Addendum No. 1
100% Construction Documents

June 10, 2025

Project:
FSU Parking Garage 1 Remodeling

ALW Project No. 19370.42

1 1st Floor Plan
3/32" = 1'-0"

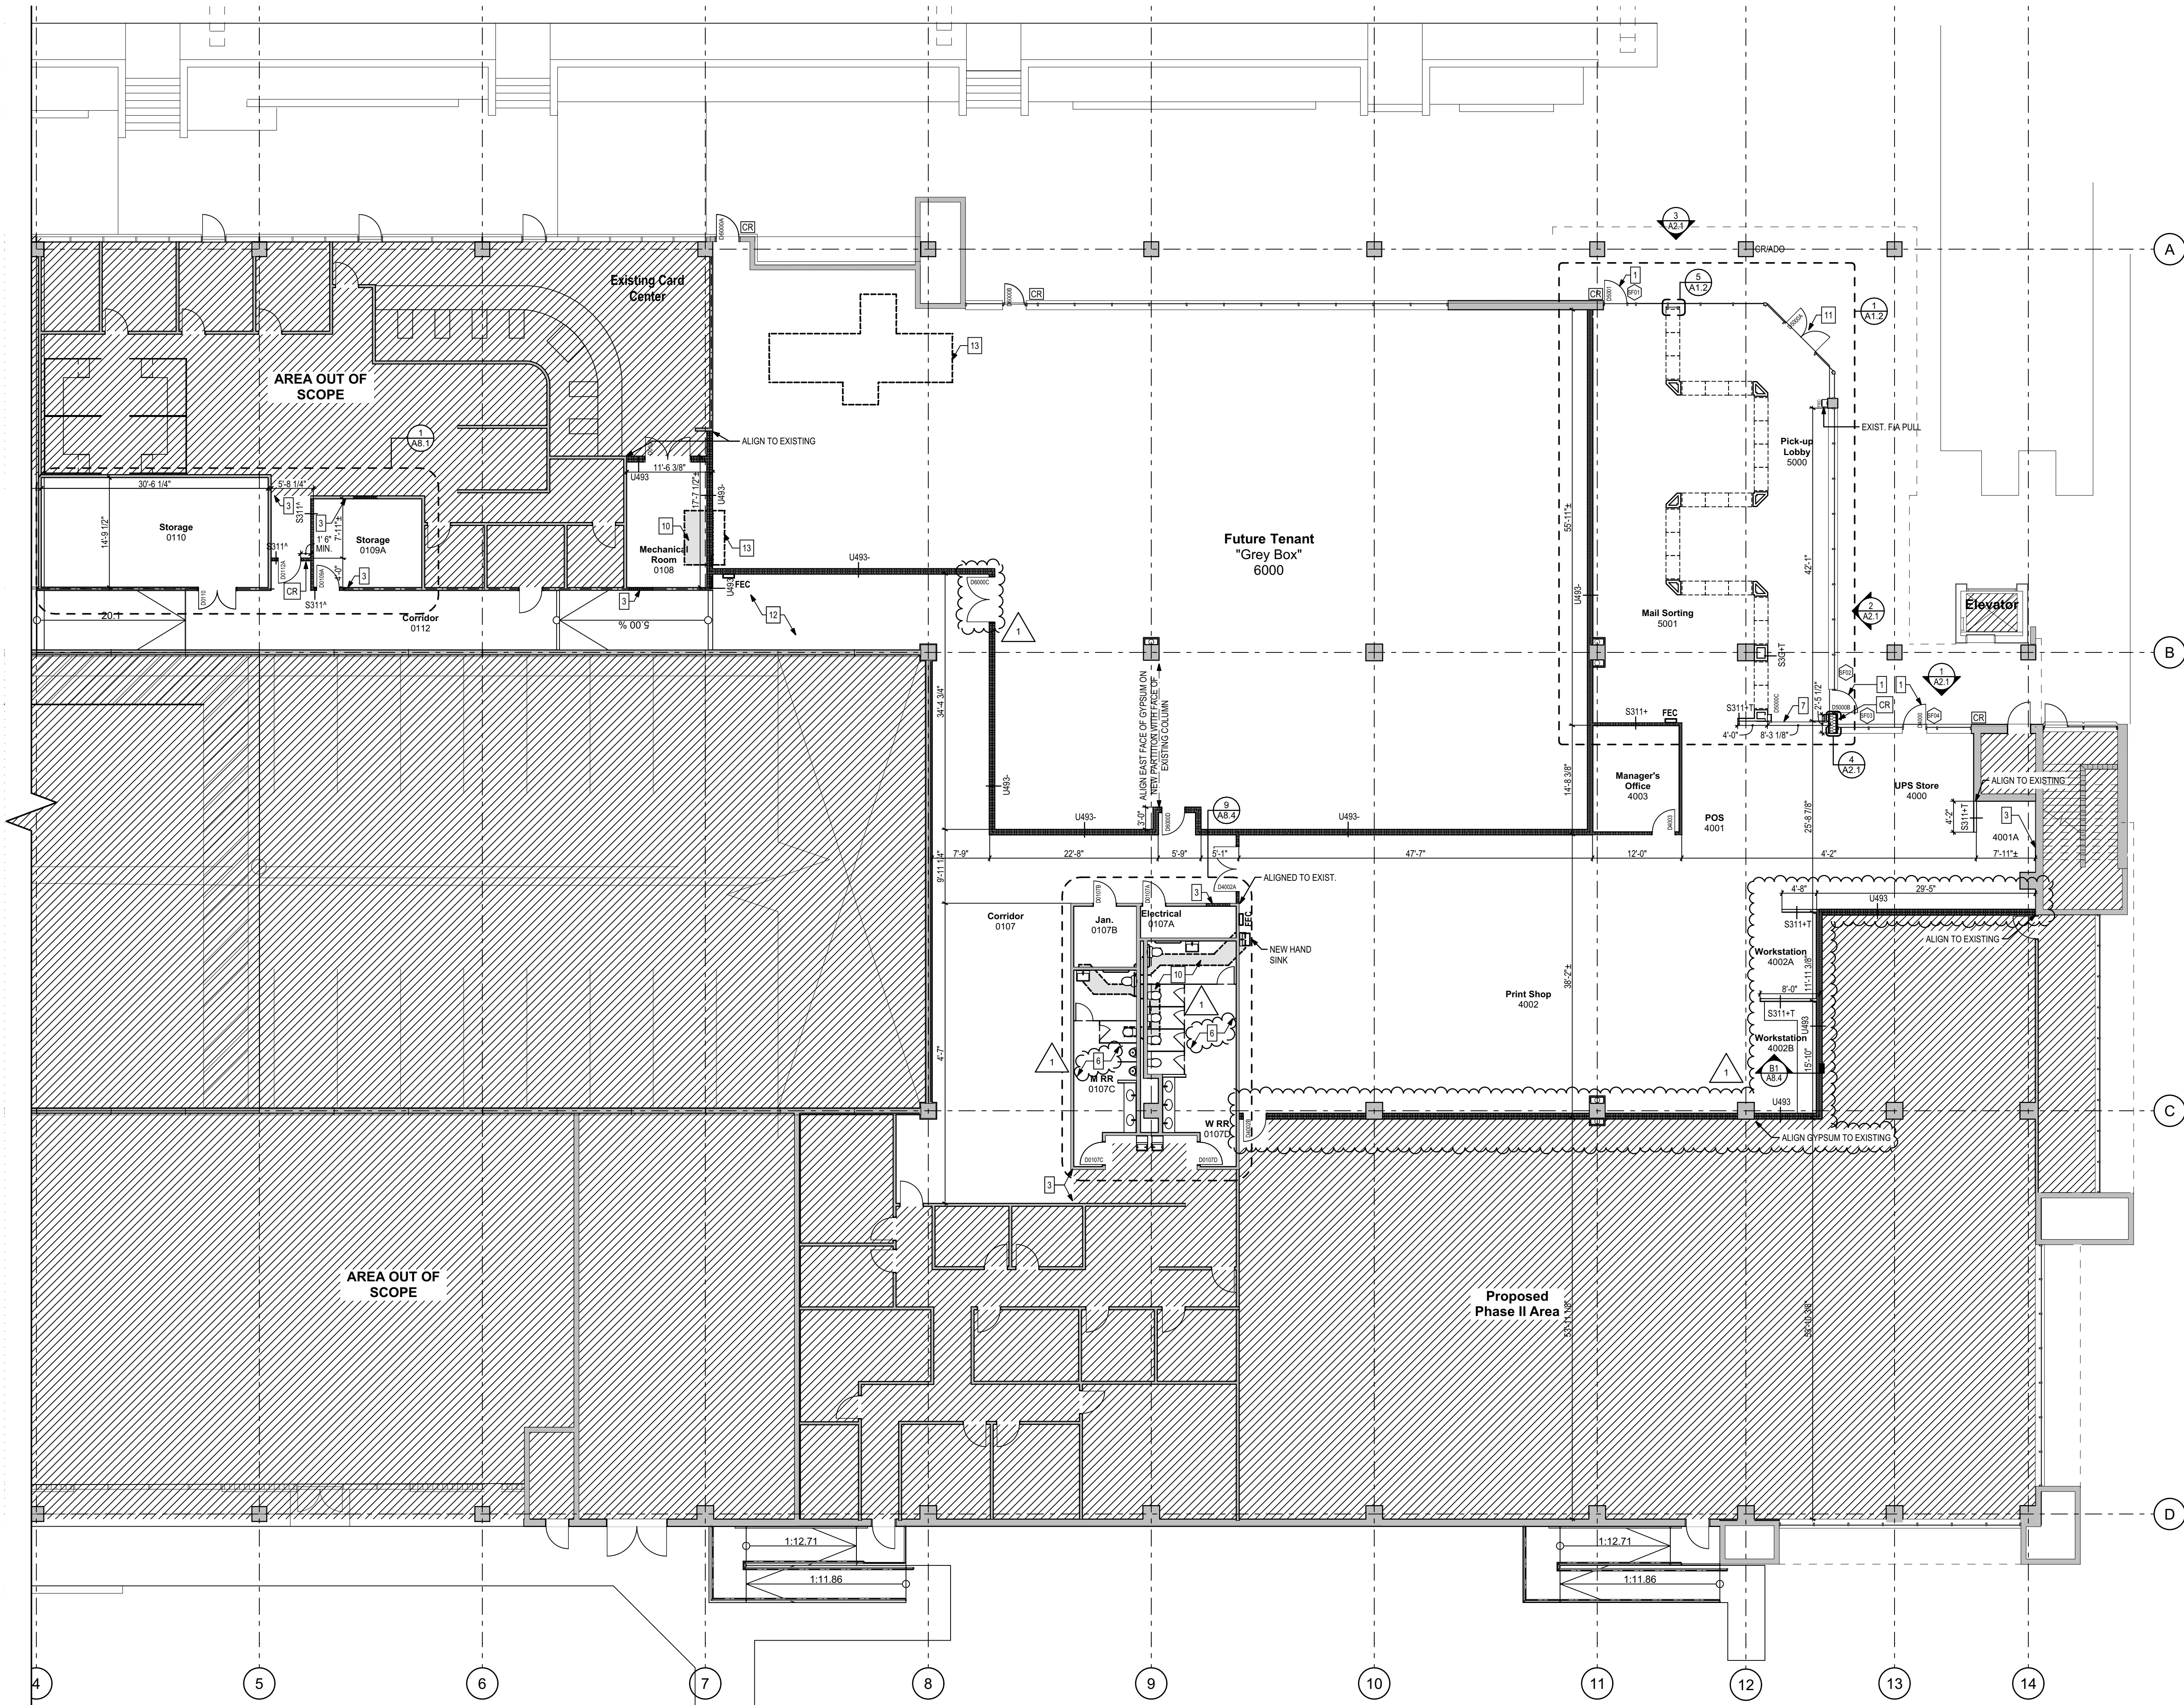
- **Revise** door D6000C to pair of doors.
- **Add** tile backer board to existing metal framin in Restrooms 3002 & 3003 (Construction Note 6).
- **Revise** partition type in Print Shop 4002 to U493

5. INSTALL NEW DOOR, FRAME, AND CASING WITHIN EXISTING WALL. INSTALL BRACING ABOVE AS NEEDED. SEE ELEVATIONS AND DETAILS.
6. INSTALL 5/8" TILE BACKER BOARD OVER EXISTING WALL FRAMING. THIS ROOM IN ITS ENTIRETY.

2 Enlarged Plan at Loading Dock
1/4" = 1'-0"

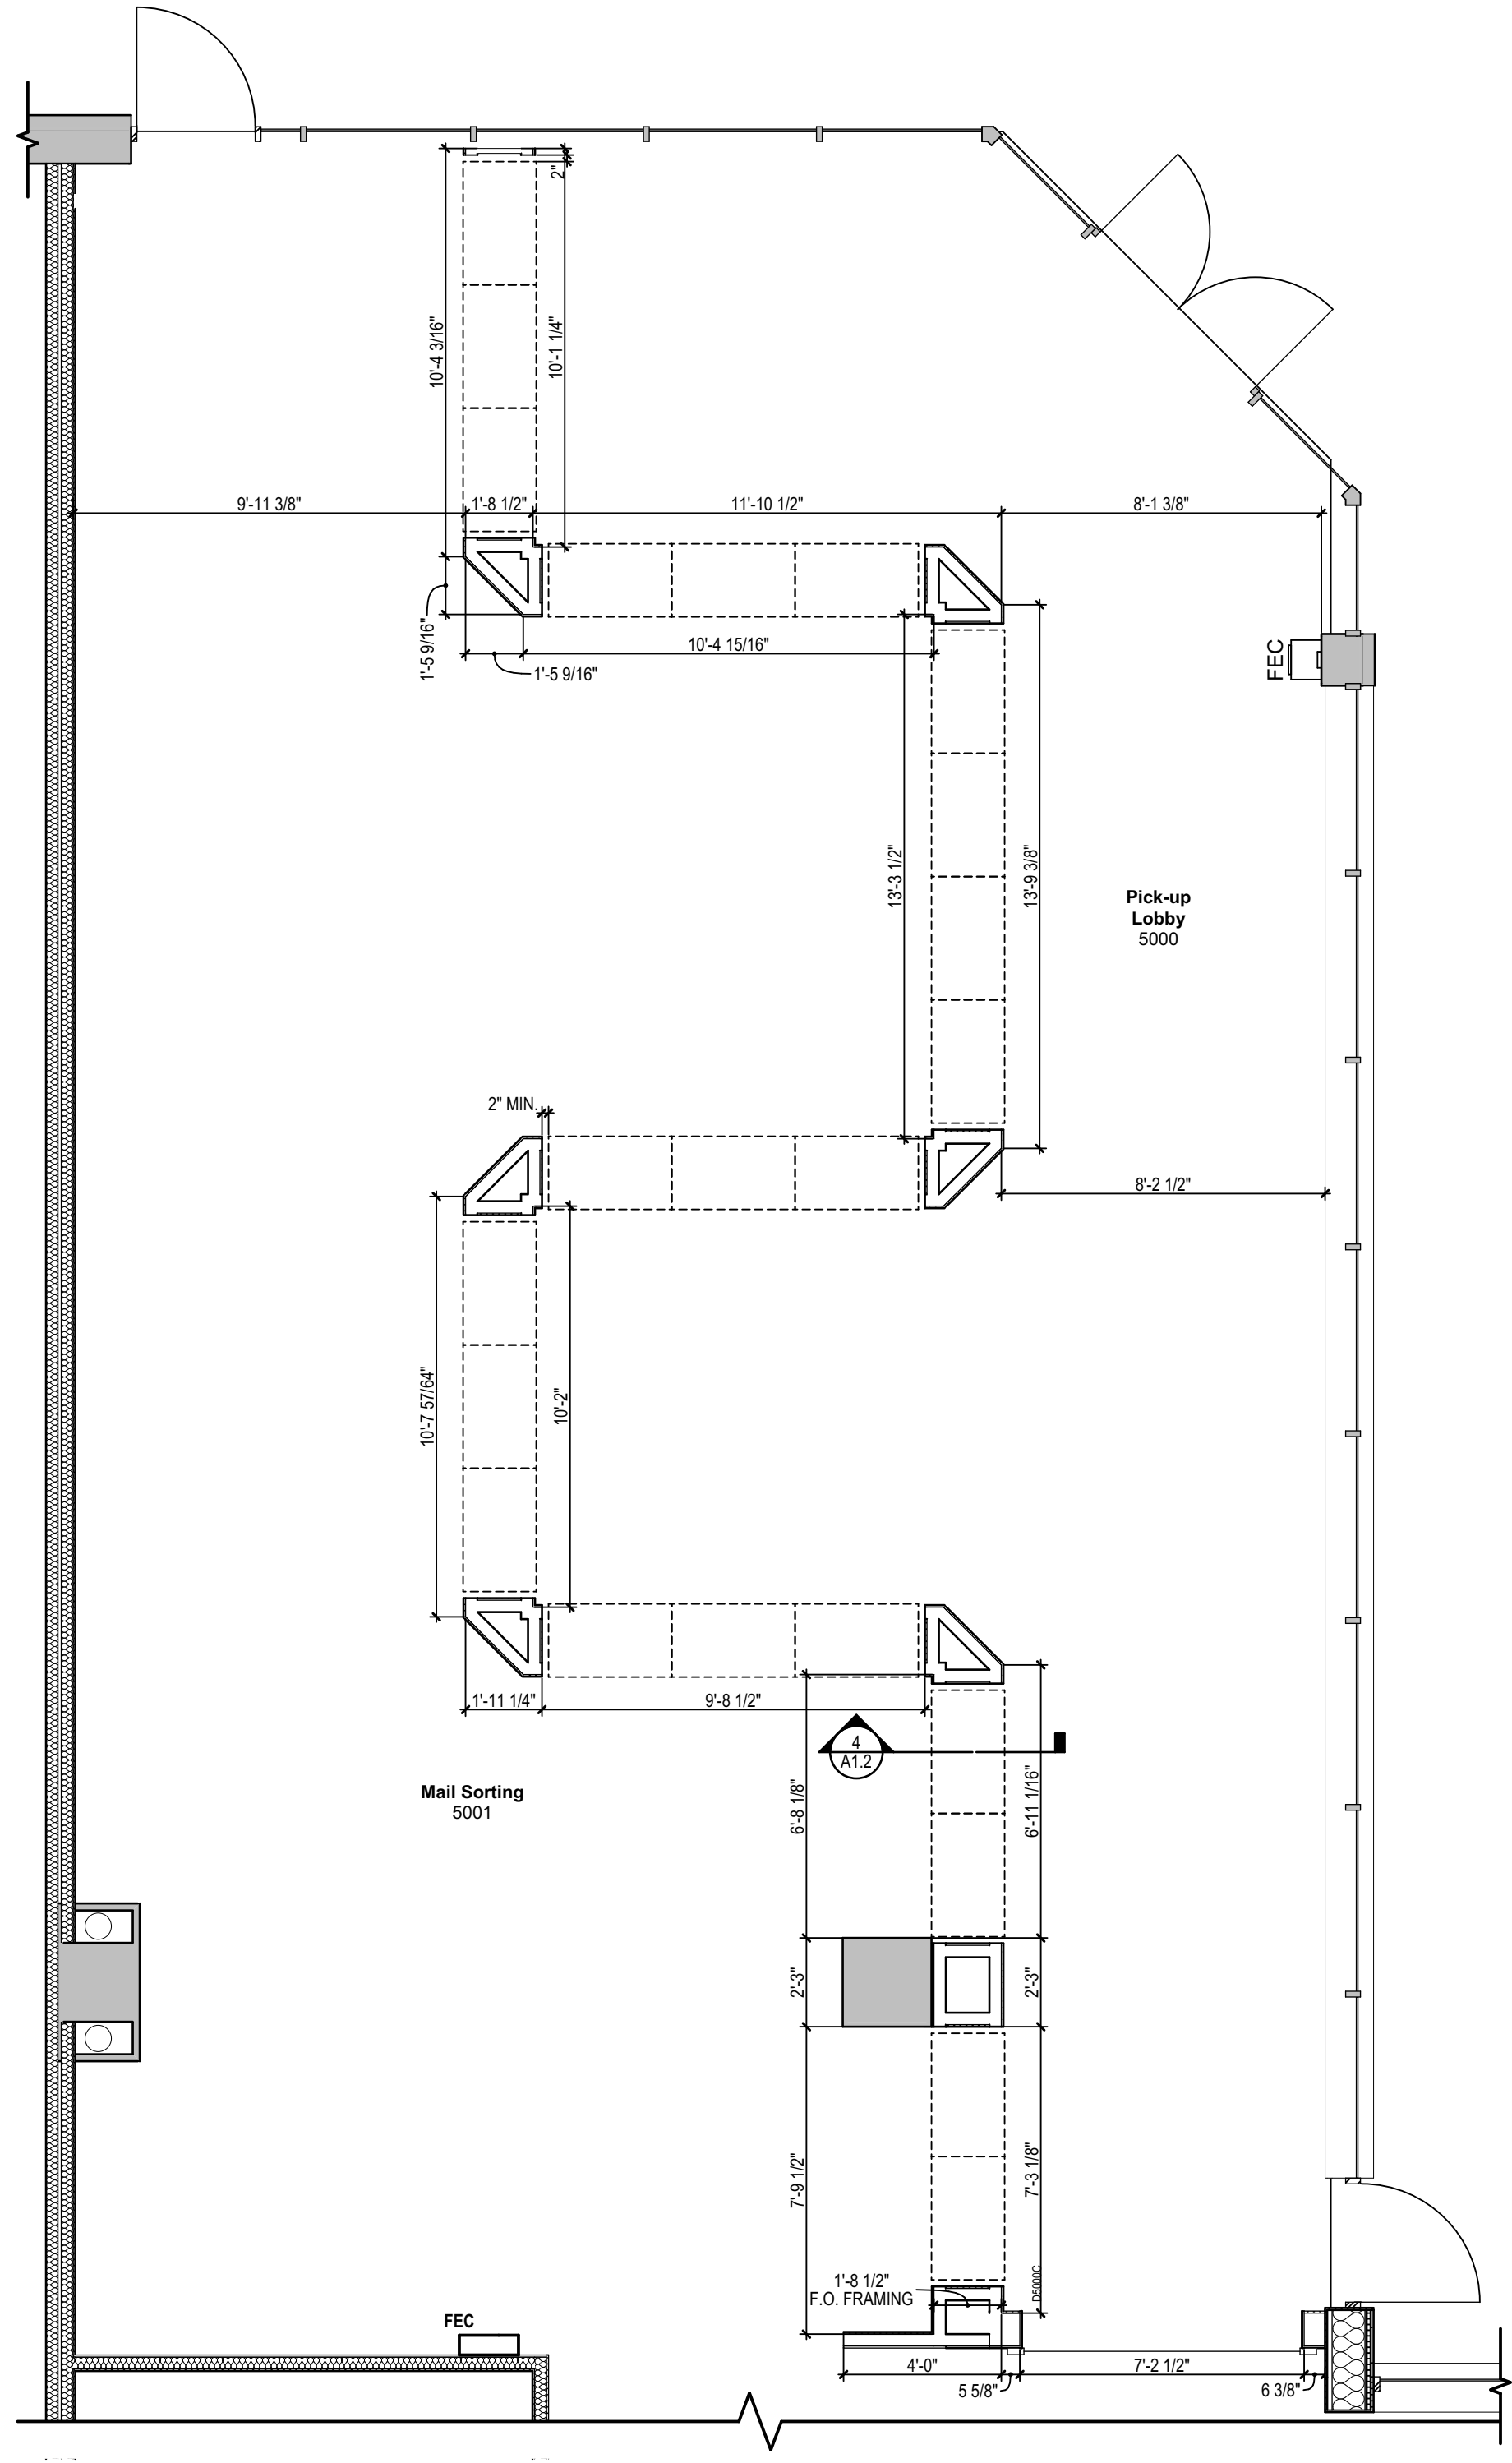
- **Revise** door number in detail 2 to D0112B.
This revision is in response to BCA's Plans Compliance Review.

A6.1

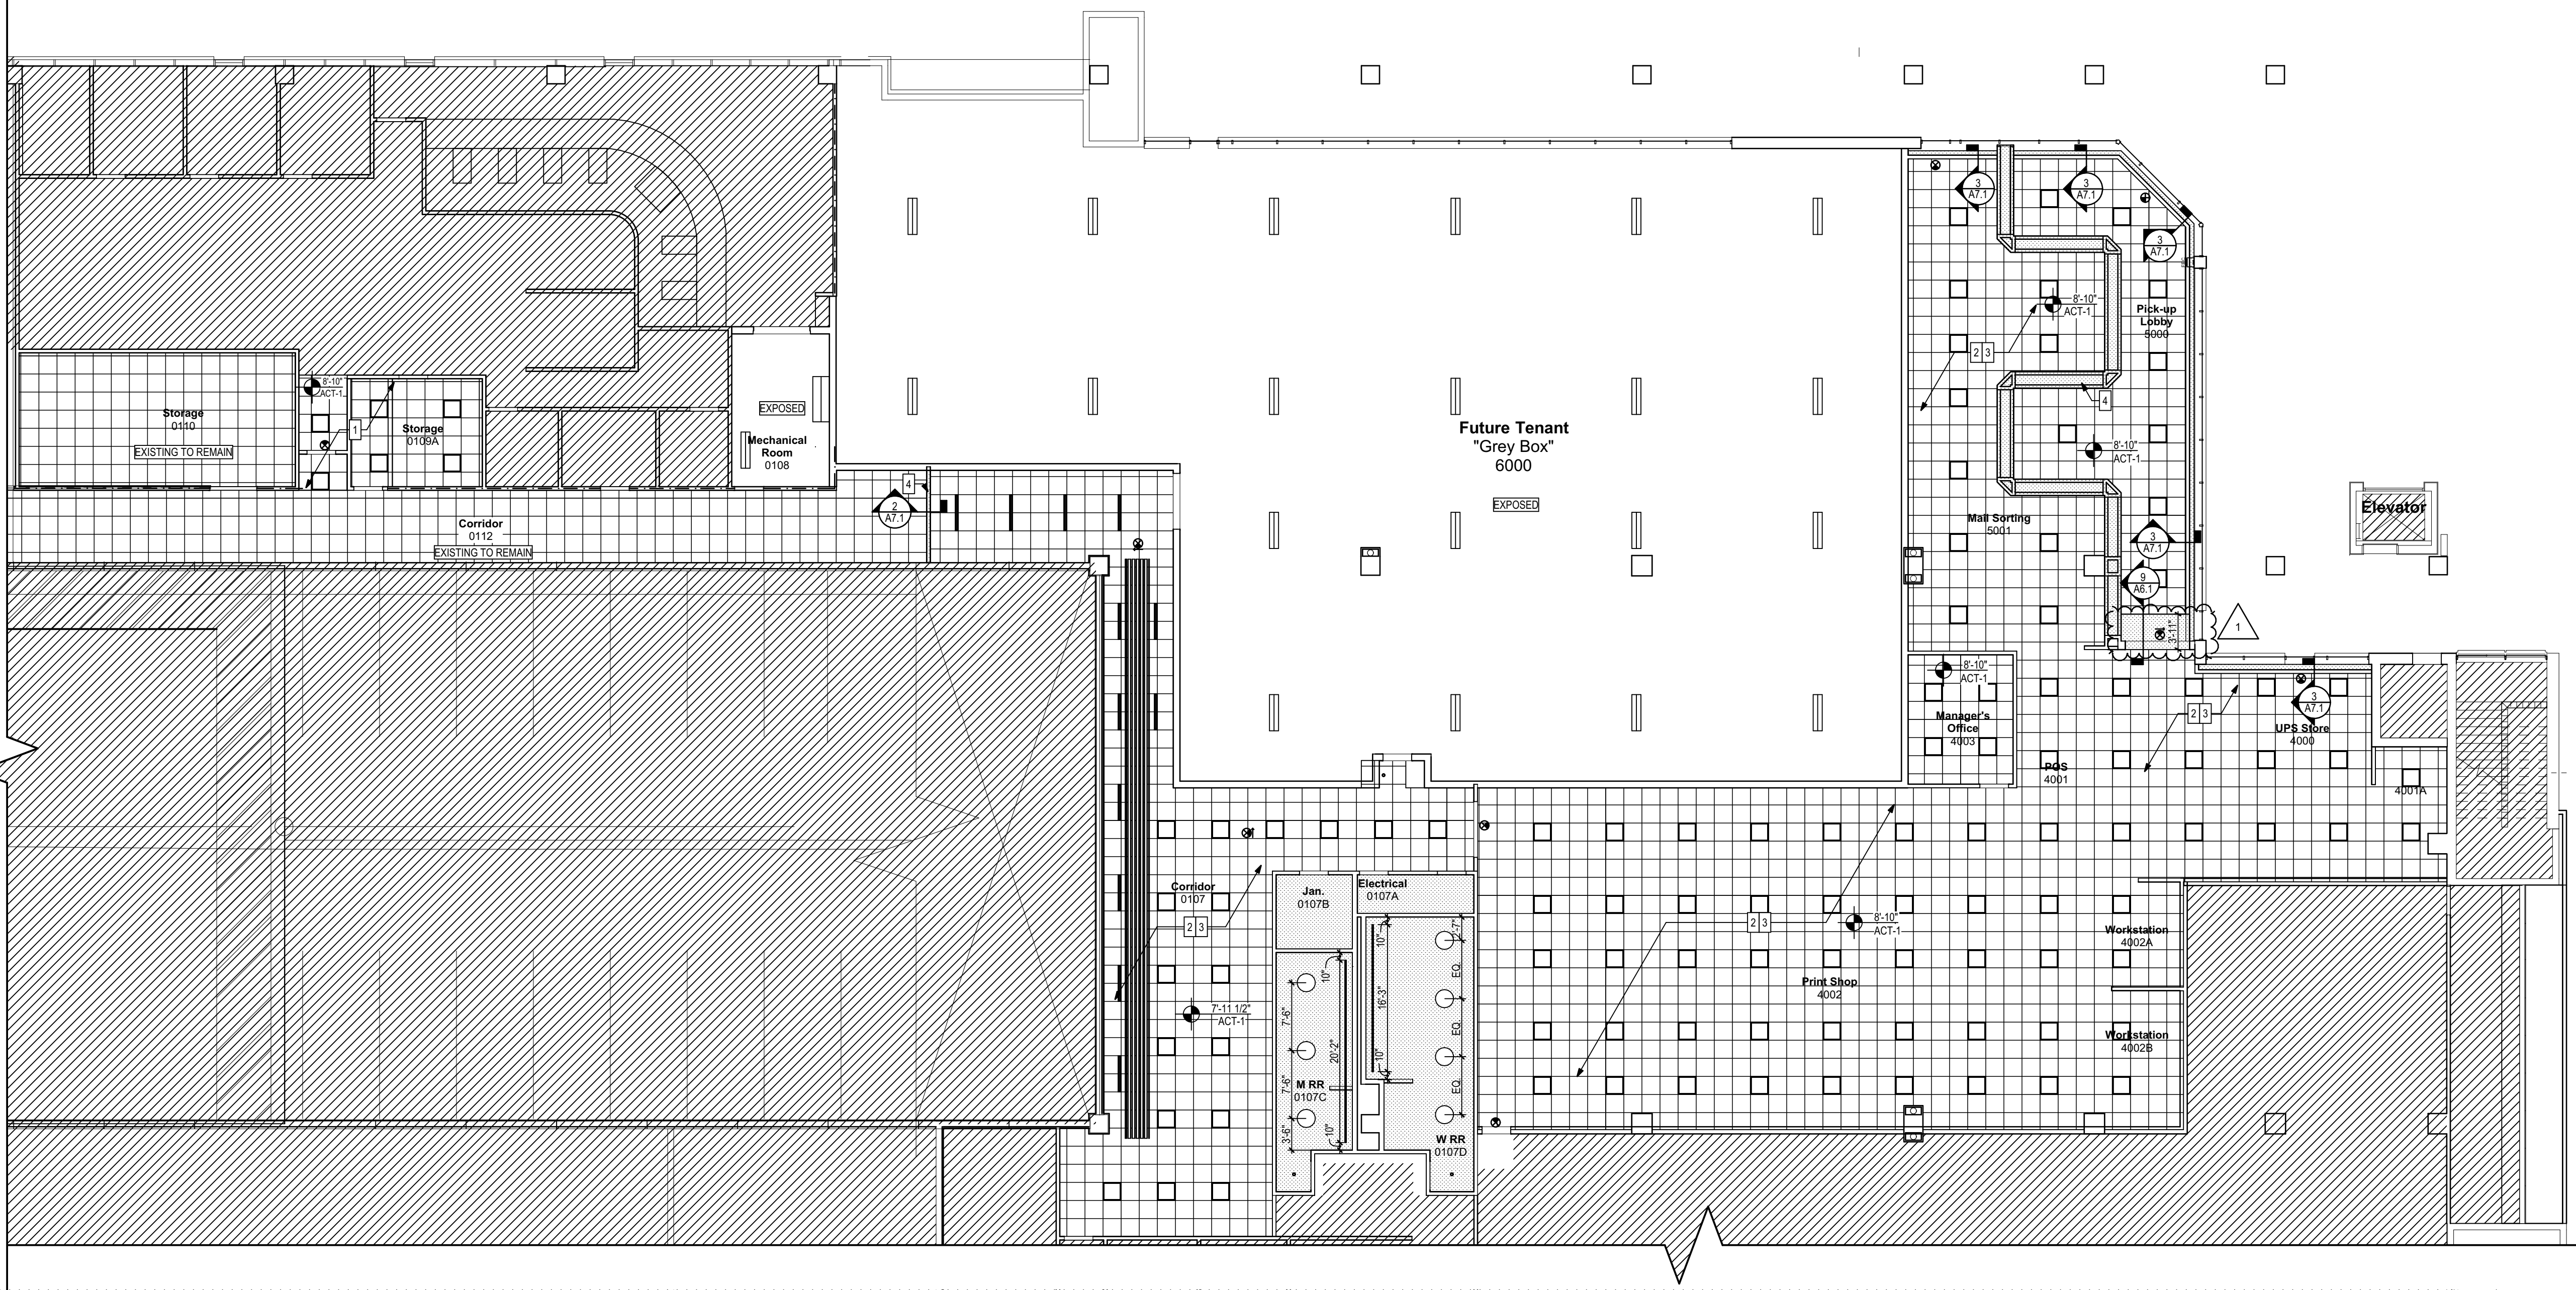
- **Revise** Door D6000C to pair of doors.
- **Revise** door hardware to Door D6000C to set #7.

D4002A	Print Shop	Interior	B	PR 3'-0"	7'-0"	HM	PAINT	F2	6/A6.1	5/A6.1	1/A6.1	HM	PAINT	A	7 3
D4002B	Print Shop	Interior	A	3'-0"	7'-0"	HM	PAINT	F1	6/A6.1	5/A6.1	3/A6.1	HM	PAINT	A	8 3
D4003	Manager's Office	Interior	B	3'-0"	7'-0"	WOOD	STAIN	F1	6/A6.1	5/A6.1	3/A6.1	HM	PAINT	A	9
D5000A	Pick-Up Lobby	Exterior	SF	3'-0"	7'-0"	ALUM	DARK BRONZE	F1	12/A2.1	7 & 9/A2.1	5/A2.1	ALUM	MATCH EXISTING	YES	6 1, 2
D5000B	Pick-Up Lobby	Interior	D	7'-0"	8'-0"		#4 STAINLESS STEEL	6/A6.1	5/A6.1	7/A6.1	SEE SPECS	SEE SPECS	A		11
D5001	Mail Sorting	Exterior	SF	3'-0"	7'-0"	ALUM	DARK BRONZE	F1	12/A2.1	7 & 9/A2.1	5/A2.1	ALUM	MATCH EXISTING	YES	6 1, 2
D6000A	Future Tenant	Exterior		Existing			EXISTING	Existing					EXISTING		11
D6000B	Future Tenant	Exterior	SF	3'-0"	7'-0"	ALUM	DARK BRONZE	F1	12/A2.1	7 & 9/A2.1	5/A2.1	ALUM	MATCH EXISTING	YES	6 1, 2
D6000C	Future Tenant	Interior	A	PR 3'-0"	7'-0"	HM	PAINT	F1	6/A6.1	5/A6.1	3/A6.1	HM	PAINT	A	7 3
